**OVERVIEW**  
**BUCKEYE LAKE DAM**  
**ODNR PHASE III**

Re: INTERIM REPORT  
BUCKEYE LAKE DAM

**BUCKEYE LAKE DAM  
REVIEW OF EMBANKMENT STABILITY**

**BUCKEYE LAKE DAM  
REVIEW OF EMBANKMENT STABILITY****INTRODUCTION**

FIGURE 1

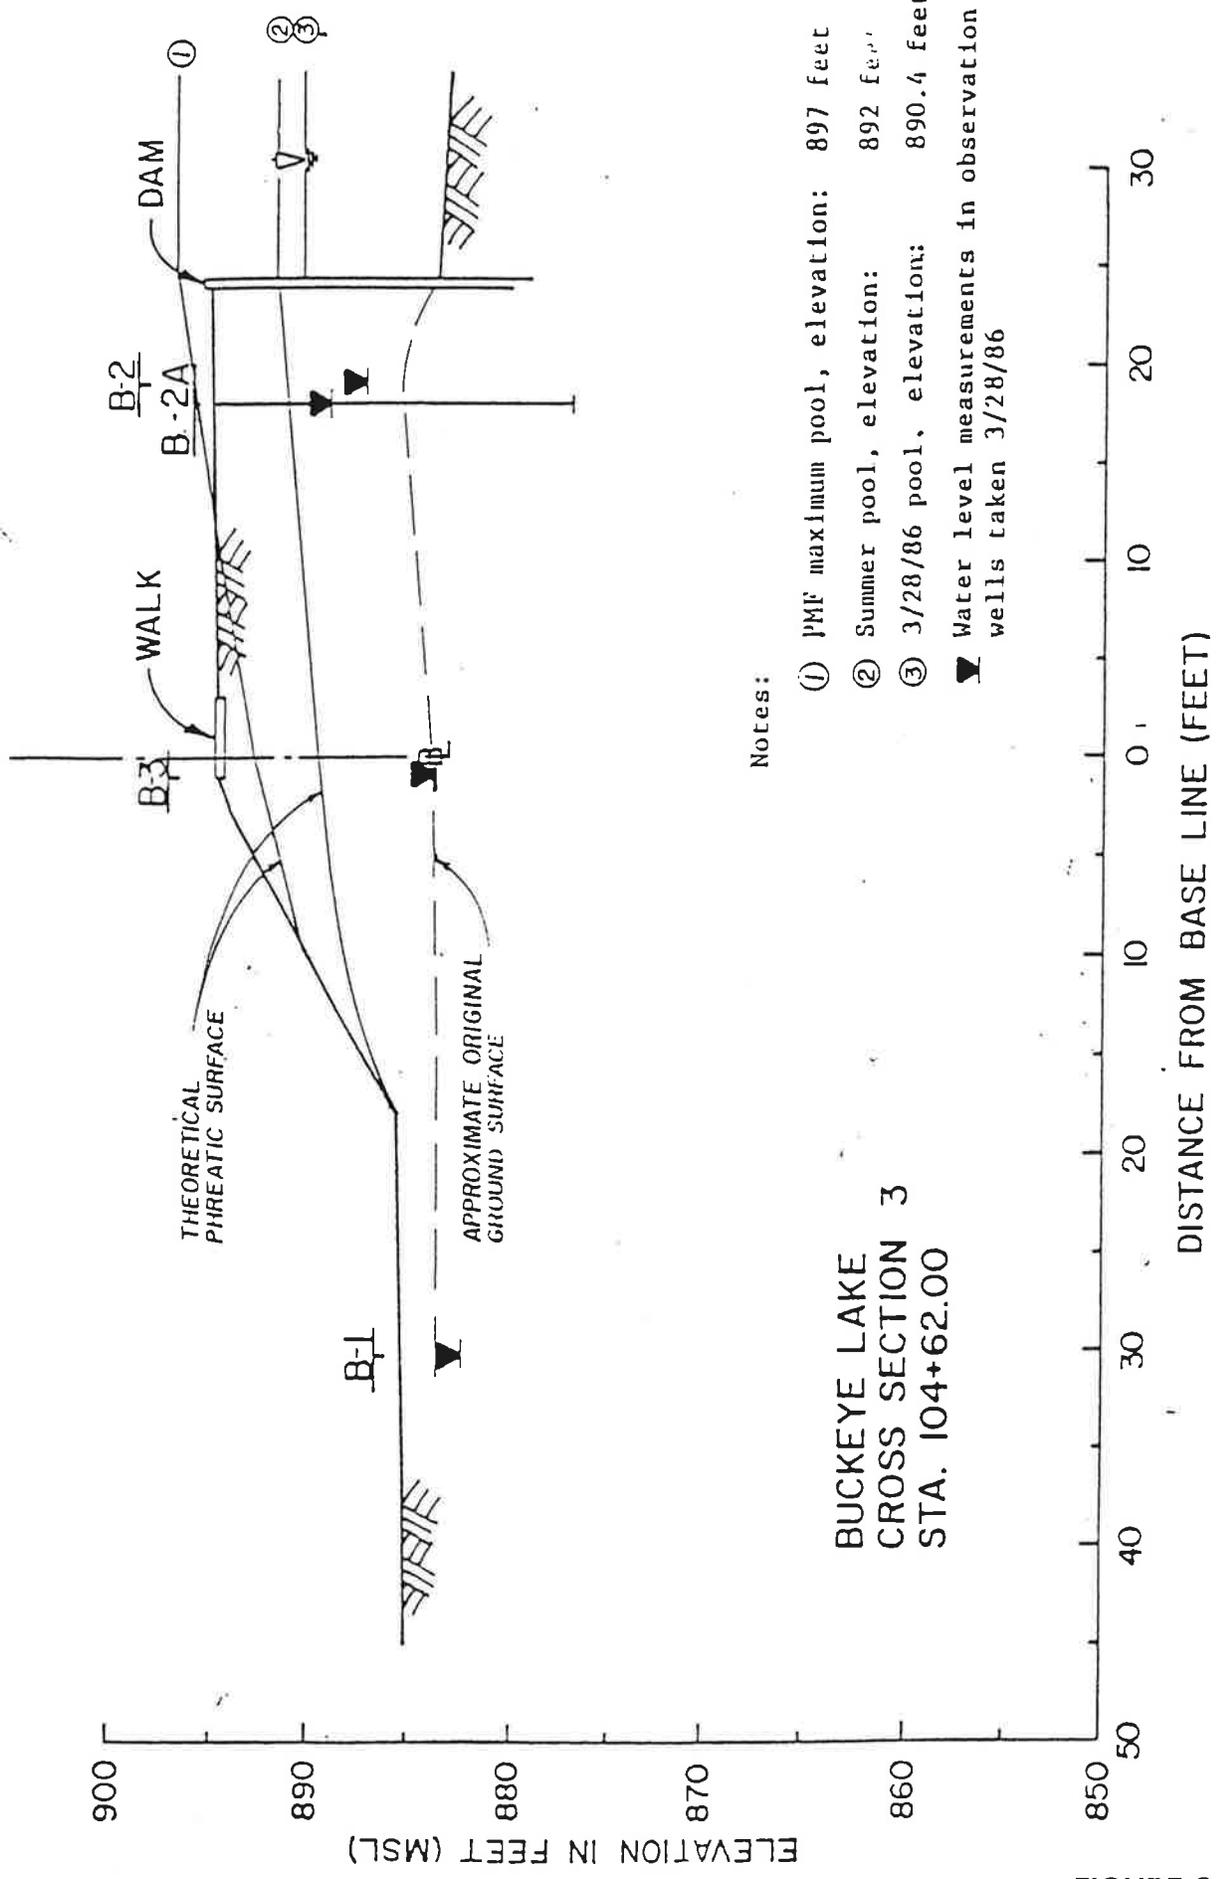
In summary, sand and/or silt partings and seams were encountered in the embankment and foundation of the dam, primarily at Cross Sections 2 and 3. In addition, Boring 2A of Cross Section 3 reported significant seepage through the sand seams within the embankment. In Cross Section 4, water seepage was encountered in all of the borings at various depths with the exception of Boring 4A. The seepage was encountered in the foundation soils below the embankment soils at a depth of 6.2 ft. below the dam crest. It is also noted that the current phreatic surface is lower than the summer average.

**CROSS SECTION 2  
FACTOR OF SAFETY vs POOL ELEVATION**

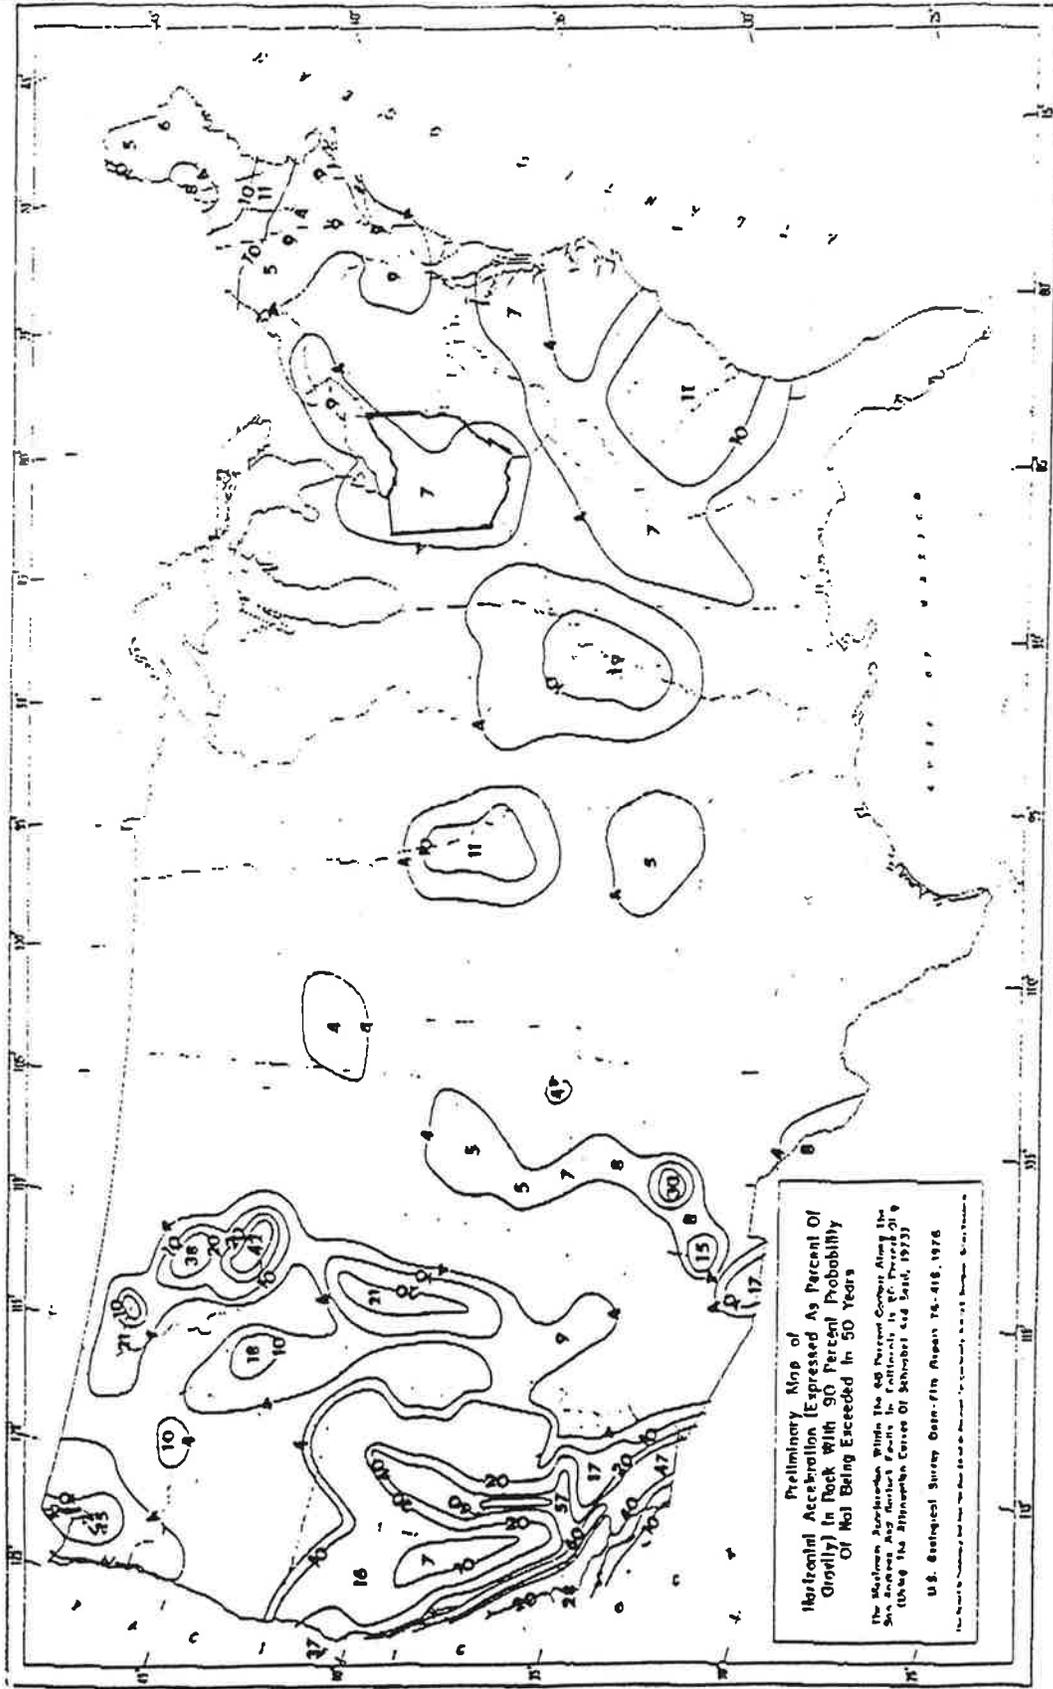
Based on the STABL 5 slope stability programs, Figure 4 provides safety factors as a function of the pool elevations of the dam. Thus, safety factors for a variety of pool elevations can be determined for both the Modified Bishop and Janbu slope stability analyses.

Based on the results of the independent stability analyses, it is concluded that the DLA study has been reasonably conservative in predicting safety factors for the Buckeye Lake Dam. The most significant findings are the low safety factors found in Cross Section 2, whereas the safety factors of Cross Sections 3 and 4 have significantly larger safety factors. As shown in Table 3, the safety factor is marginal with a pool at and above elevation 895. This is indicated by a safety factor of essentially 1.0. In addition, there are other factors that further increase the risk of failure. These include seismicity effects and the probability that there will be less stable embankment zones within the dam which have not been investigated.
